SUBJECT: CERTIFICATION OF THE MINUTES OF THE ACRS
SUBCOMMITTEE ON THE AP1000 REACTOR,
DECEMBER 15-16, 2010, ROCKVILLE, MARYLAND

**REVISION 17 TO AP1000 DESIGN CONTROL DOCUMENT
And
VOGTLE ELECTRIC GENERATING PLANT COMBINED OPERATING LICENSE
APPLICATIONS**

December 15-16, 2010
ROCKVILLE, MARYLAND

Figure 3.7-201
VEGP AP1000 Horizontal Spectra Comparison

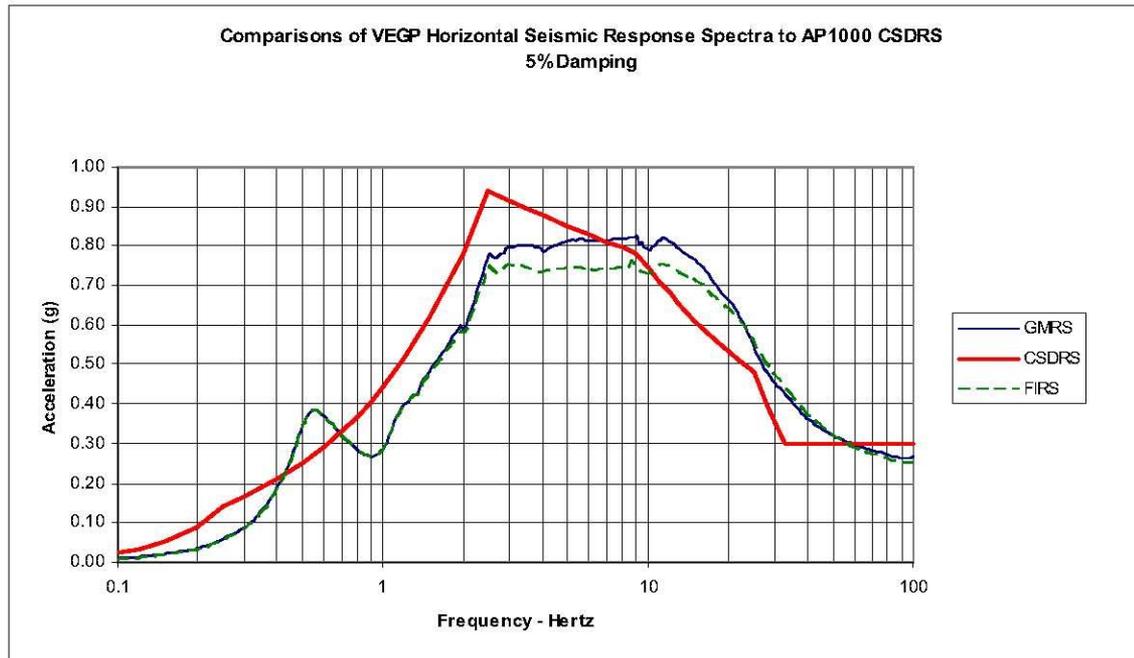
- Site-specific ground motion response spectra (GMRS) exceeds the certified seismic design response spectra (CSDRS)
- VEGP performed site-specific analysis
- Results:
At 1.67 times the VEGP GMRS, all in-structure response spectra (ISRS—6 locations evaluated) were bounded by the DCD ISRS
